EAST TOWN CROSSING FRONTAGE IMPROVEMENTS

COVER SHEET

EAST TOWN CROSSING SHAW ROAD IMPROVEMENTS

SHEET NO.
SL.1

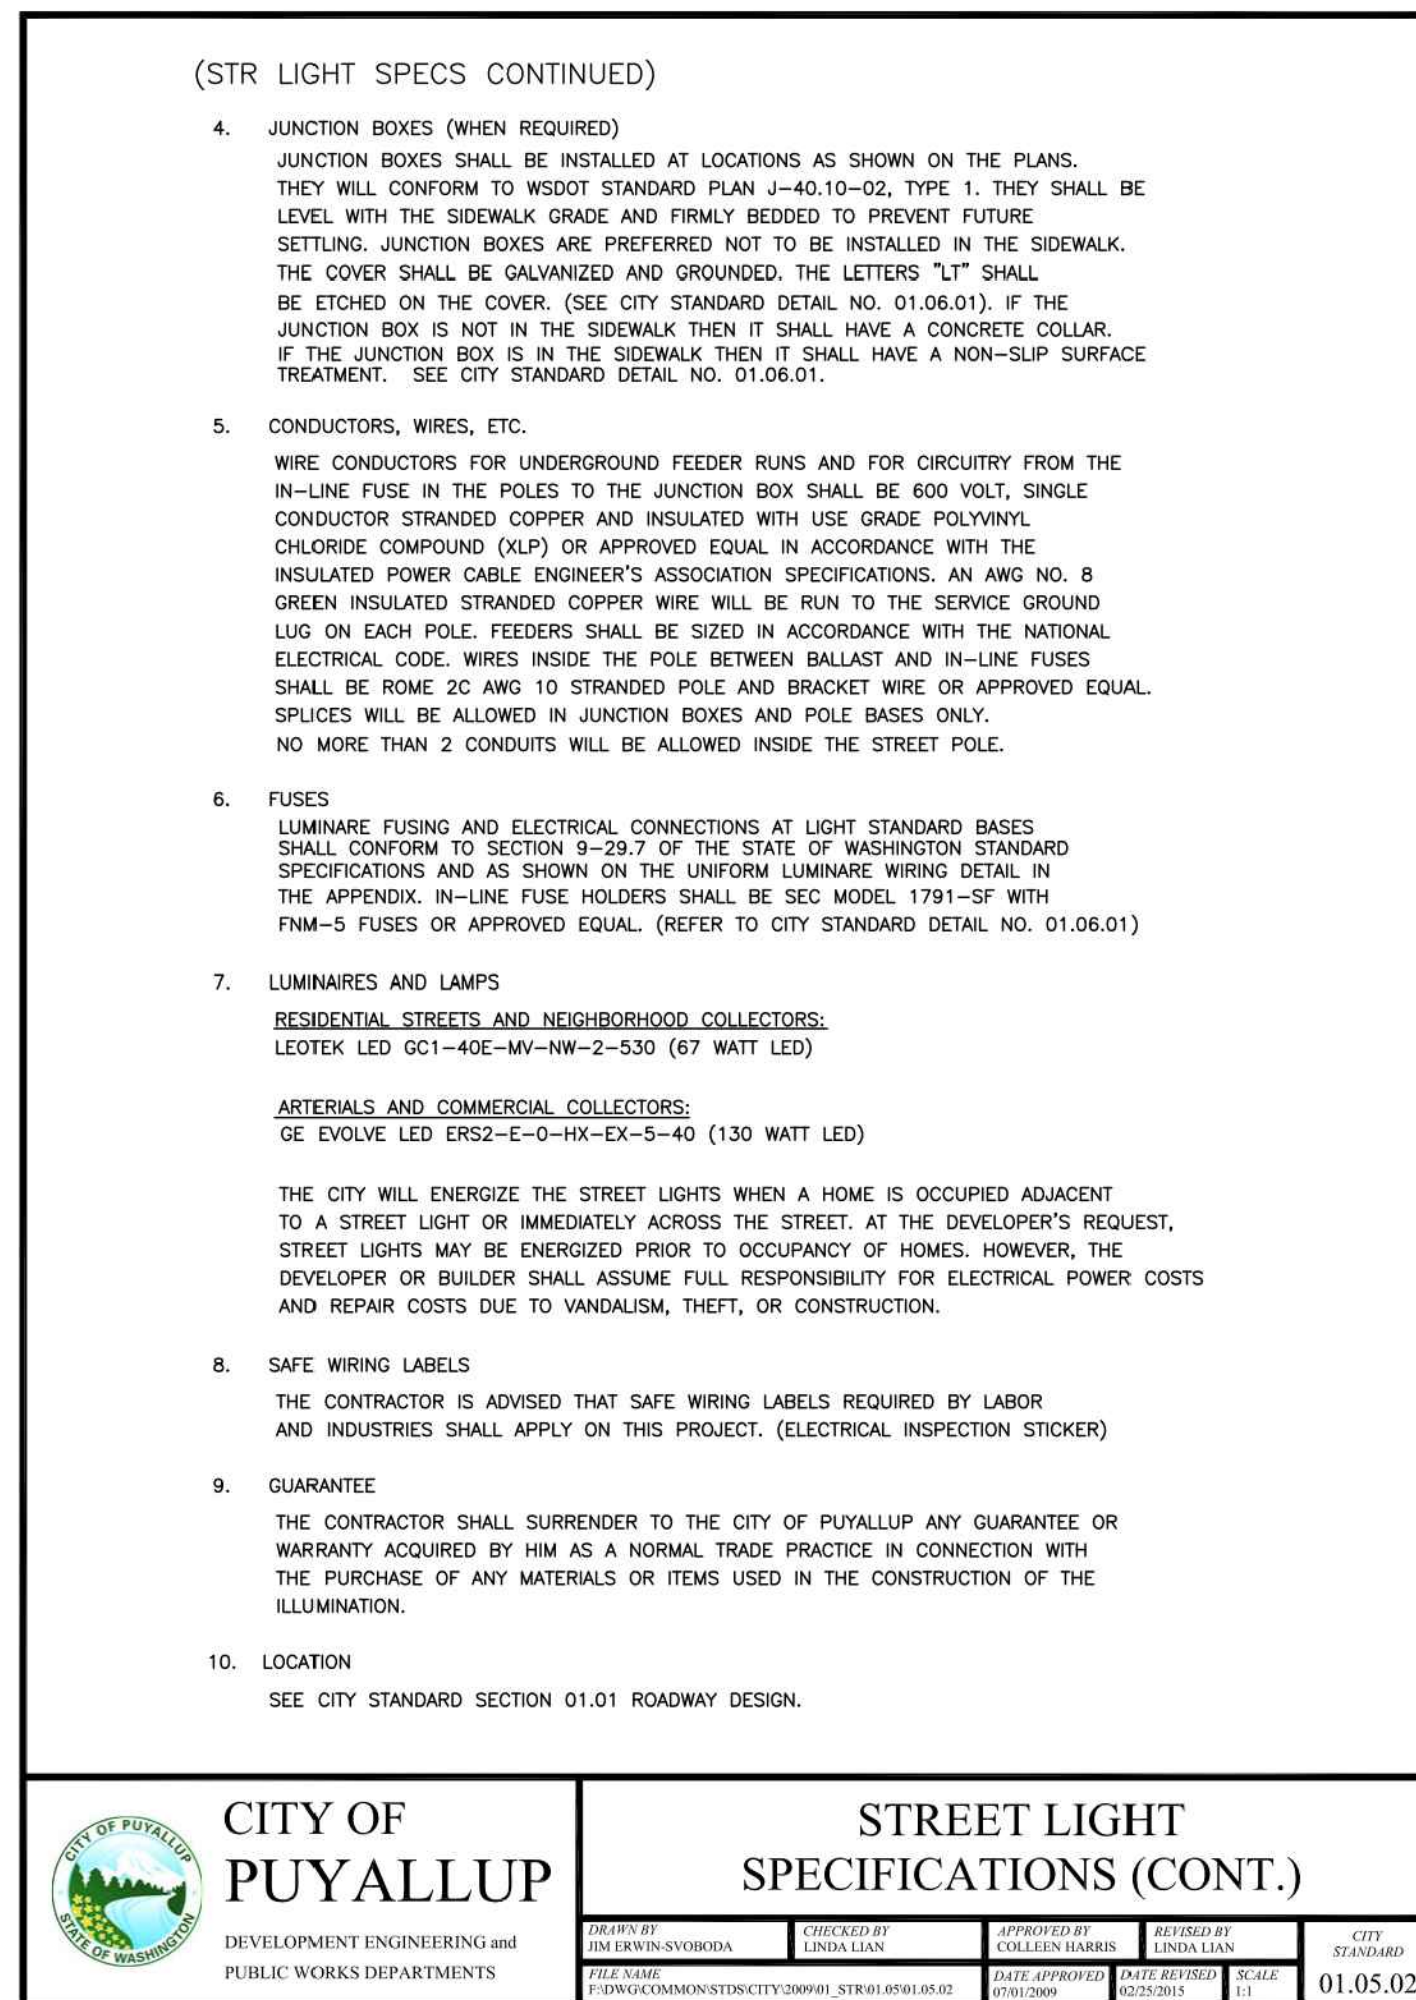
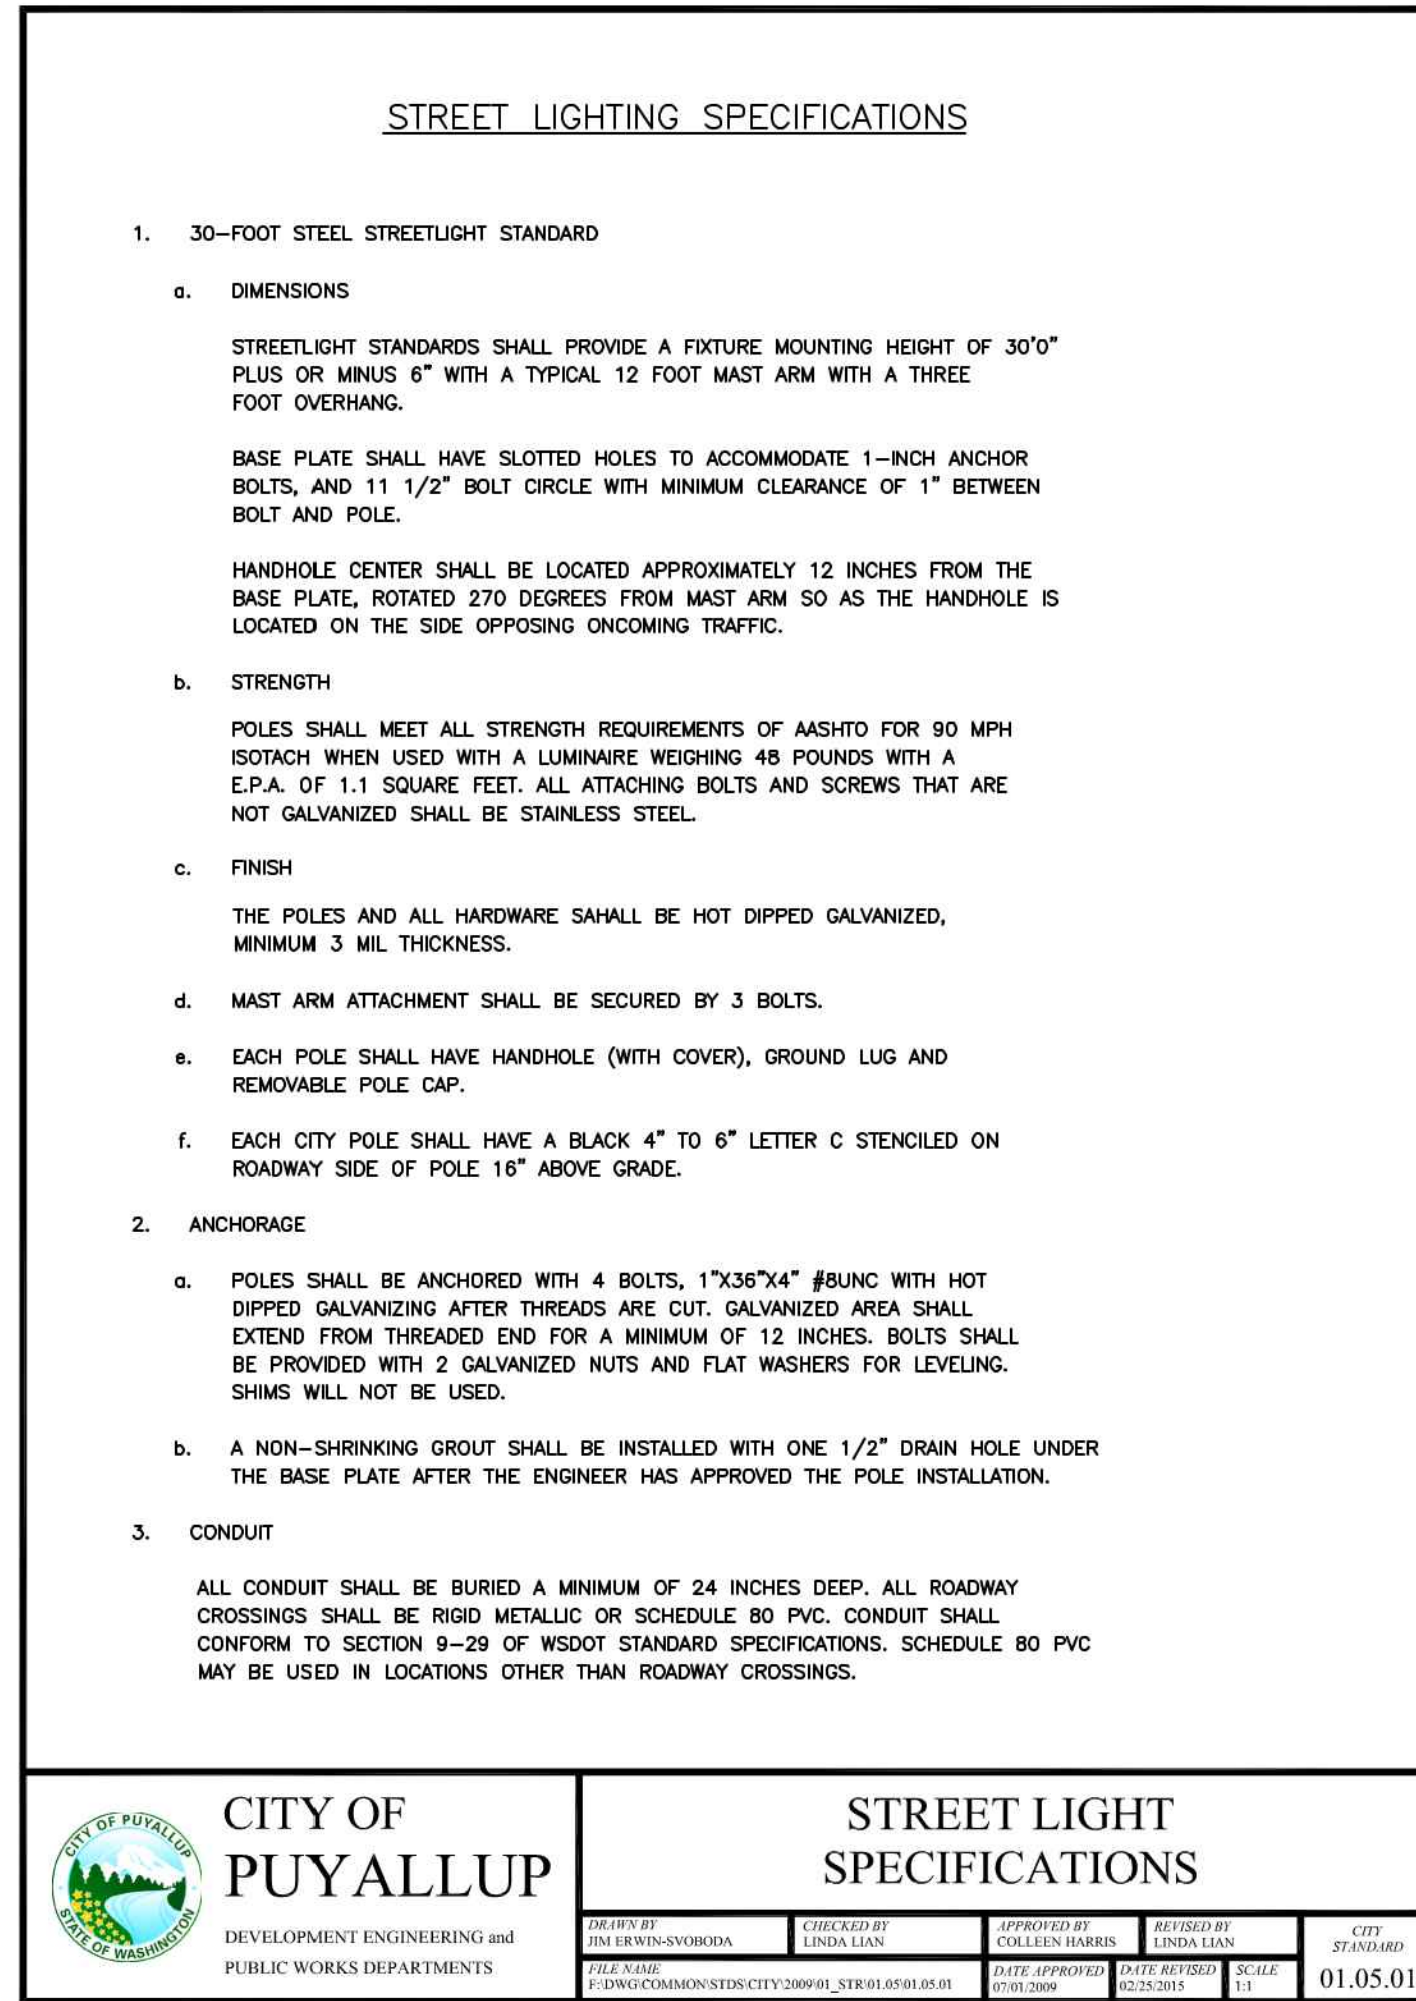
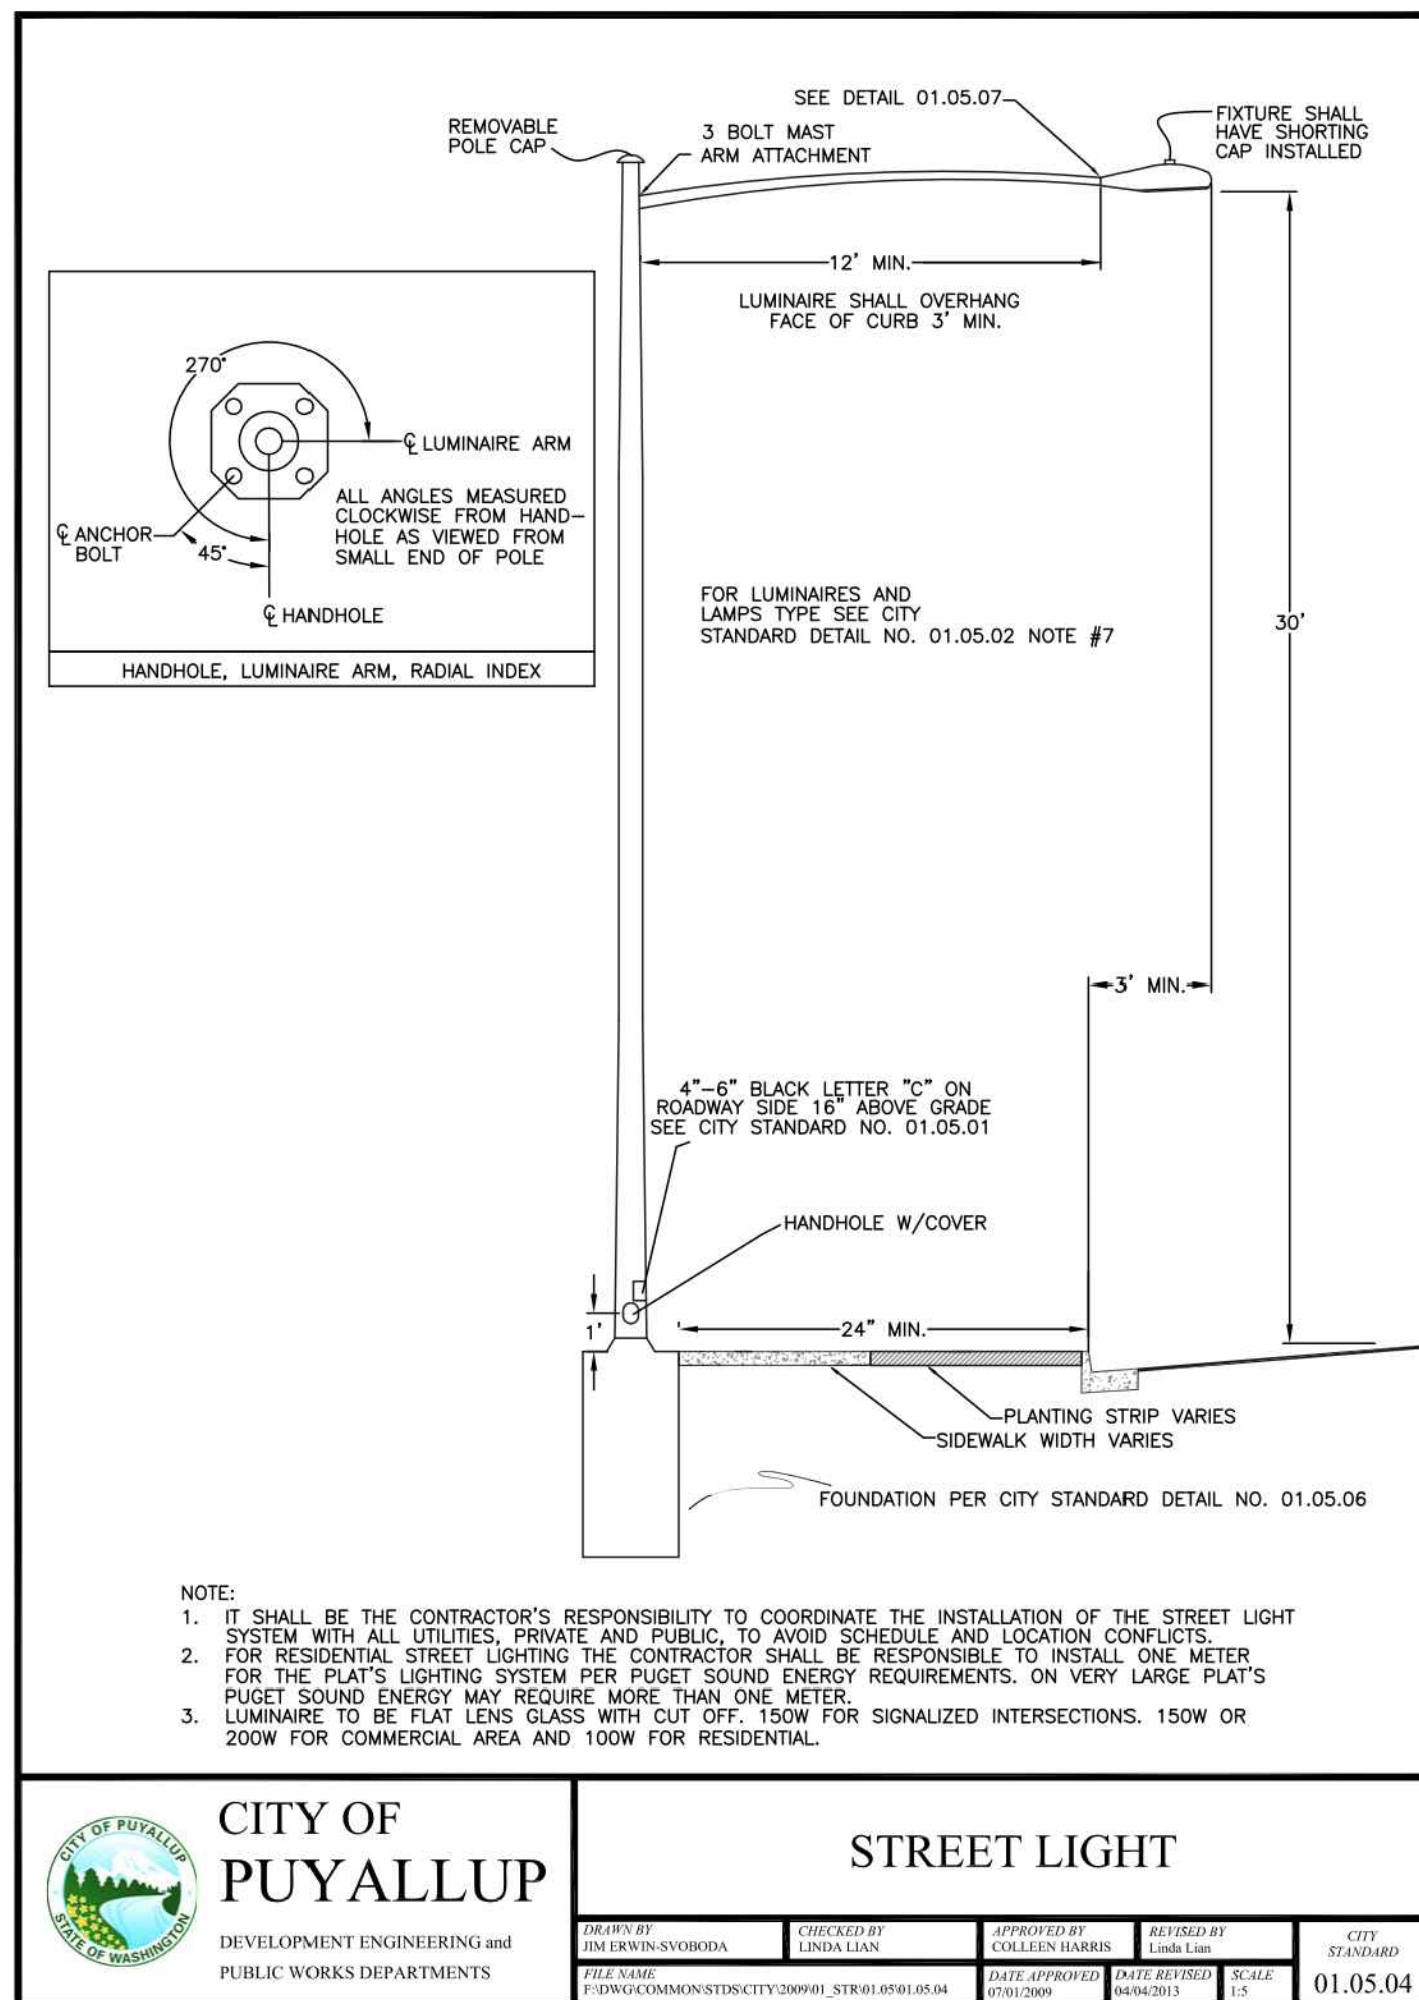
Lighting engineer to verify proposed design will meet or exceed WSDOT light level requirements for pedestrian facilities. Average (fc): 0.8 Uniformity: 4:1 Civil Plans - SL.1

Add the following to Note 6:
*6a. A copy of the load calculations shall be provided to the City's signal technician prior to installation.
*6b. Contractor shall contact the City's signal technician when the lights are ready to be energized.
[Plans; Sht SL.1 of 21]

show where J-box location will be, armorcast J-boxes should be used. SL.1 SH

show actual location of new underground conduit, in right-of-way SL.1 SH

Frontage design not consistent with other sheets in this submittal. Civil Plans - SL.1

If underground conduit at new approach, confirm Sch. 80 PVC conduit or replace if necessary. [Plans; Sht SL.1 of 21]

J-box and (2) runs of conduit to extend to southern edge of frontage Civil Plans - SL.1

Photometric analysis needs to account for existing City standard lighting on both sides of the street (including lighting at signalized intersection). Assume utility/PSE mounted streetlights will be removed with project. Civil Plans - SL.1

City standard streetlights are required every 150ft (minimum). Project to provide GE EVOLVE ELR2 Fixtures ERL2-3-23-A3-40-D-Gray-A-V1 (City to provide latest part numbers) How will lights be powered? New service cabinet? Using the existing signal service cabinet? Streetlights shall have shorting caps installed with remote photocell located on the service cabinet. Civil Plans - SL.1

show what streetlights are existing and what are new. previous page states remove and relocate streetlight/power pole, which ones will be moved, verify conduit continuity and ability to maintain and pull wire if needed, add extra 2" spare conduit throughout width of project, our standard states schedule 80 conduit under roads/driveway...has this been verified it exist, if not replace with schedule 80 across entrance & verify and state existing wire size and it meets current standards.... SL.1 SH

It is the sole responsibility of the design engineer to ensure streetlight design/placement is outside of the 10ft minimum "safe zone" area. The City will not allow streetlights to be within 10ft of the PSE primary for safety reasons. Place this note on this sheet Civil Plans - SL.1

Streetlight design shall provide the following:
1. Provide details on how streetlights will be powered
2. Location of conduit runs
3. Wiring Schedule
a. Conduit size and type for each raceway
b. Conductors details
4. Pole schedule
a. STA & offset for each luminaire
5. Show location of junction boxes
Civil Plans - SL.1

is this the same one on sheet 7 that says relocate, if it going to be removed why does the sidewalk curve around it SL.1 SH

At proposed City light standard locations, encapsulate the light base into the sidewalk and/or shared use path pour. [Plans; Sht SL.1 of 21]

Clearly identify as being removed. Existing PSE utility pole mounted streetlights do not meet current City standards and will be removed with installation of City standard streetlights. Civil Plans - SL.1

Clearly identify as being removed. Existing PSE utility pole mounted streetlights do not meet current City standards and will be removed with installation of City standard streetlights. Civil Plans - SL.1
